## Table of Contents

The Blaine Aquifer is one of the first four aquifers required to be studied prior to December 1, 2016. The Daniel B. Stephens & Associates Inc. (DBS&A) team was selected by the TWDB to complete the brackish groundwater study of the Blaine Aquifer. DBS&A team members include John Shomaker & Associates, Inc. (JSAI), Allan R. Standen, LLC (ARS), and Michelle A. Sutherland, LLC. The project study area is shown in Figure 2-1.

Figure 11-3. Identified sinkholes (karst features) within the study area.

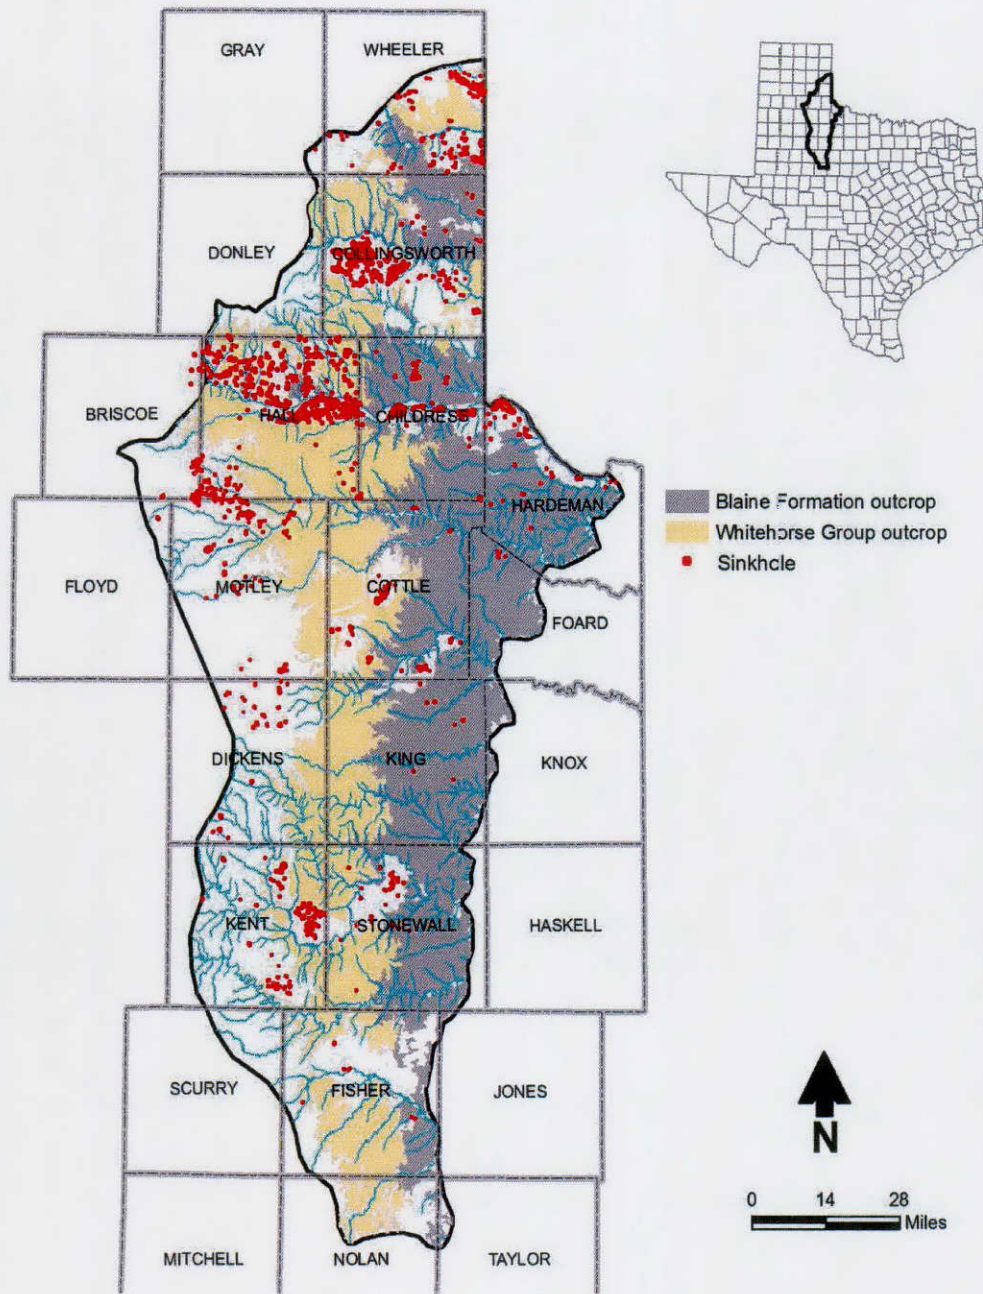
22. Section 11.1. Please provide a GIS file of cavities shown on Figure 11-3.
23. Section 11.1. Please append cavities data to the table tblWell\_Geology. If additional data fields are necessary to fully attribute these features, prepare a custom table.

Figure 12-2. Blaine Aquifer system salinity zones illustrated on a three-dimensional visualization of the water table at 50x vertical exaggeration.

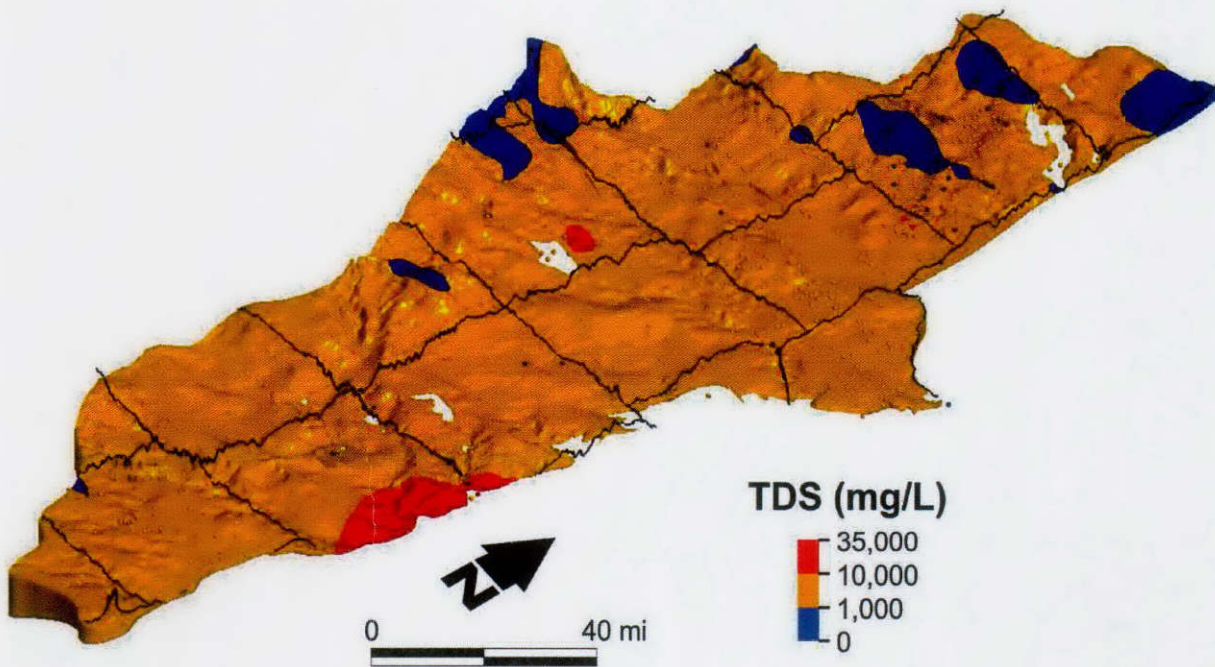
6. Figure 12-2. Please consider adding county line overlay, a north arrow, and a figure caption that described the salinity zones in terms of TDS ranges and colors.

Figure 13-2. Estimated elevation of brine interface where it occurs above the base of the Blaine Formation.

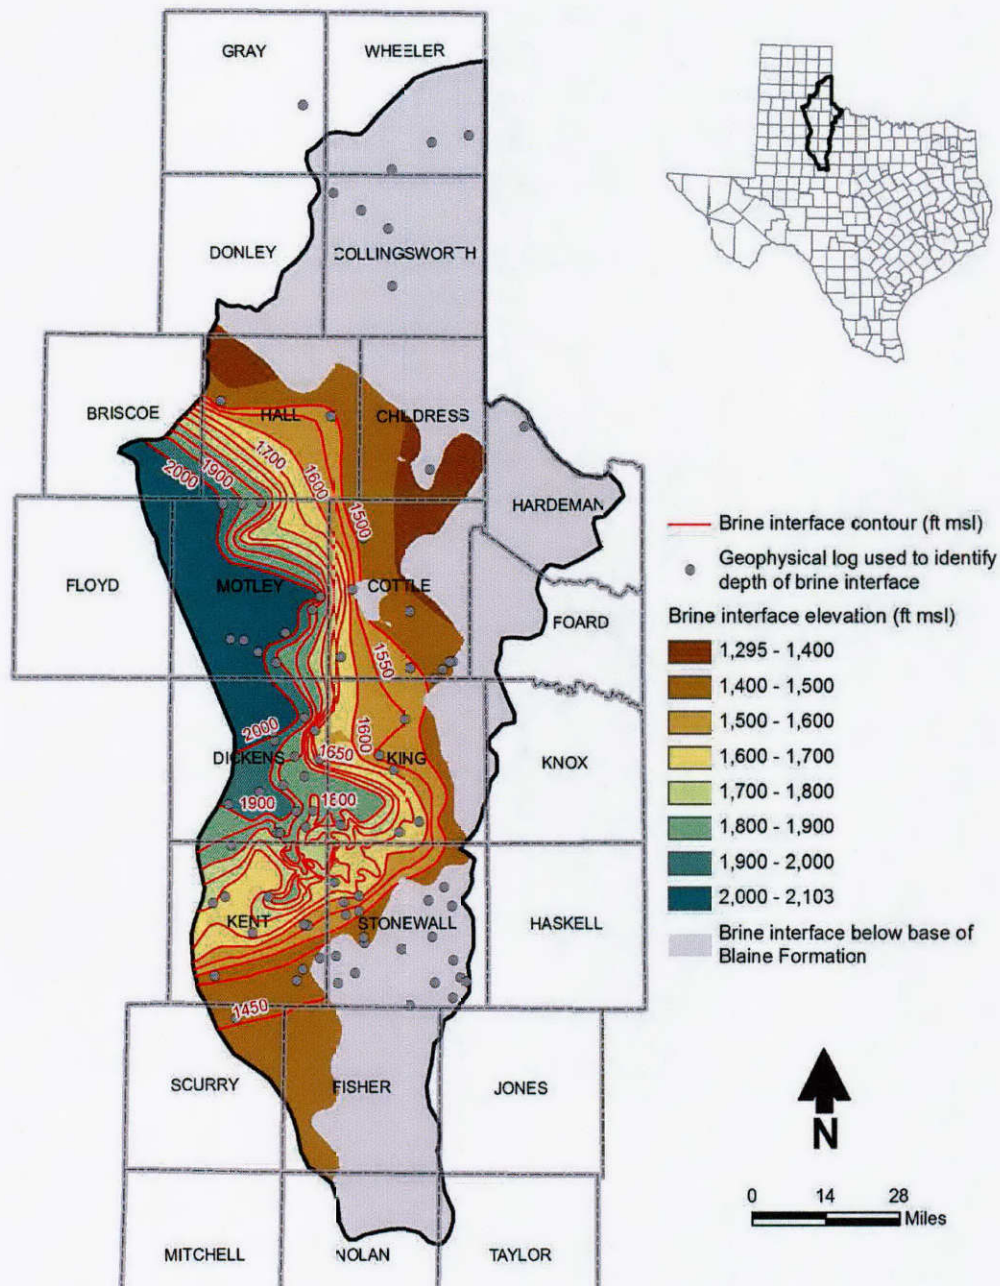
7. Figure 13-2. Please modify this figure-by:
  - a. Correcting the legend so elevations are in integers.
  - b. Providing a polygon showing the lateral extent of the brine interface where it occurs above the base of the Blaine Aquifer System.

- d. Please modify the caption to more clearly state that the contours are in feet above the base of the Blaine Aquifer System.
8. Figures 5-4, 8-3, and 13-2. Please consider including additional figure for each map using a scale in depth below ground surface.

Figure 14-3. Exclusion areas identified for shallow injection wells and protected wildlife area.

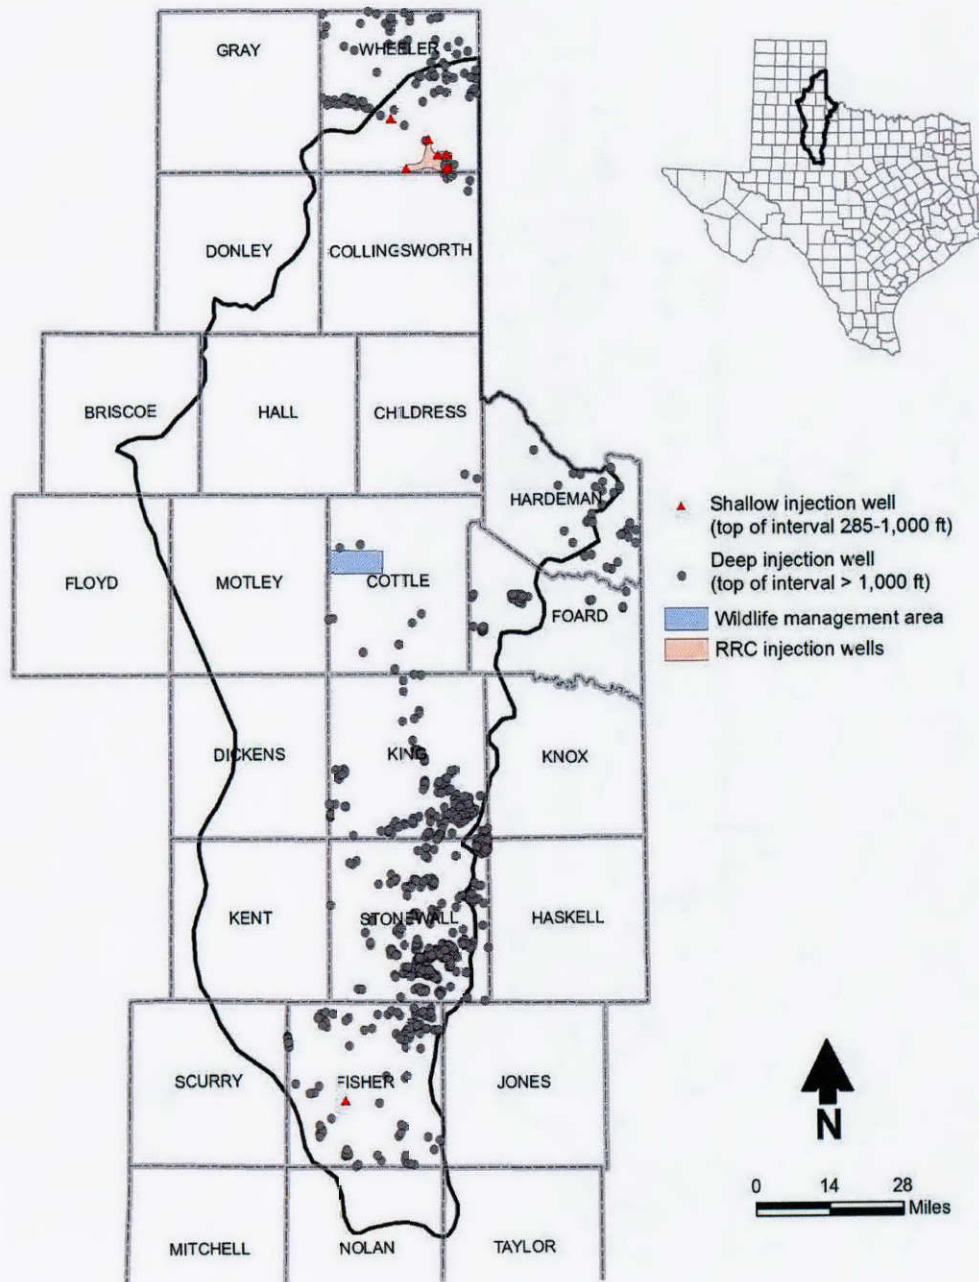
- a. Karst\_formation
  - b. Modelgrid
13. Class II injection well dataset used for the study (Figure 14-3). This information was used to determine exclusion areas for potential production areas.
